SOLICITATION W50S6Y-25-B-A004 Combine Weapons Fac- LSGA239001

Addendum 04 Q&A

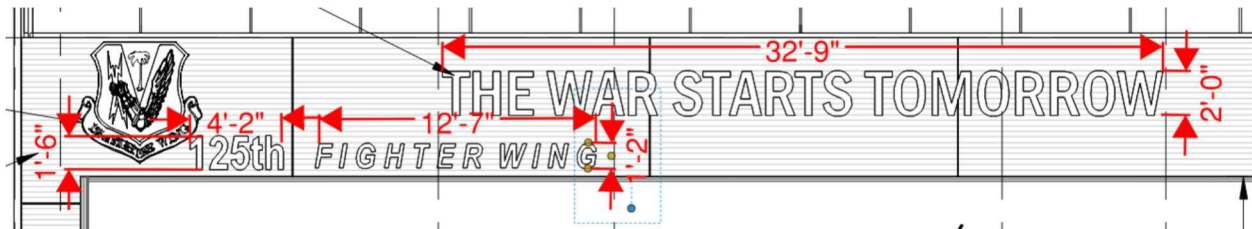
Ref. G4/A-203: Logos are noted as "GFCI". Are letters also GFCI or CFCI? IF CFCI, please provide required dimensions for letters.

AE: The Building Signage letters "125th, Fighter Wing, and THE WAR STARTS TOMORROW" are CFCI.

V. **A6** ROOM 110 MEN'S R/R NORTH ELEV.
SCALE: 1/4" = 1'-0"

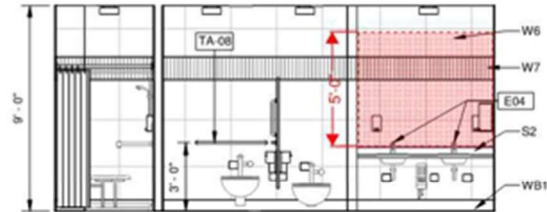
Ref. A-401: Please clarify required locations for TA-15 Full Length Mirrors.

AE: TA-15 Full Length Mirrors are not required in restroom or locker areas. The TA-06 mirrors are required over the sink countertops as show on the plans and the red marked images below:
